RE: WIPP Permit Renewal Application

Southwest Research and Information Center (SRIC) provides the following initial comments on WIPP Permit Renewal Application, dated March 31, 2020. The comments are primarily limited to issues that are inadequately discussed in the Application that could be included in a Technical Incompleteness Determination (TID). Those are some issues that SRIC will raise during the renewal process. Some documents that should be in the administrative record are identified. SRIC requests that these comments be considered in any information or TID requests that NMED provides to the Permittees.

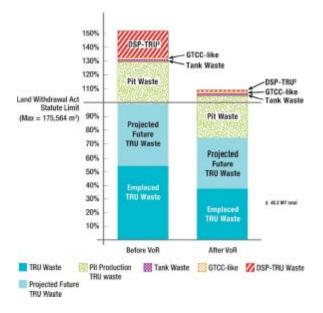
The permittees must explain their plans to fill WIPP beyond its legal capacity limit of up to 6.2 million cubic feet of waste, which they have not done in the Application. The National Academy of Sciences *Review of the Department of Energy's Plans for Disposal of Surplus Plutonium in the Waste Isolation Pilot Plant*, <sup>4</sup> released on April 30, 2020, clearly shows that those plans include waste that exceeds the WIPP capacity by about 50 percent using the correct outer container calculation, but even substantially exceeds the limit using the VOR calculation.

DOE must clearly describe the plans for amounts and types of waste to be disposed at WIPP. Since WIPP has a limited mission, DOE must describe what additional repository(ies) it will propose for wastes that exceed the WIPP capacity limit and when such facilities will be operational. None of the documents in the Supplemental Information References provide that information.
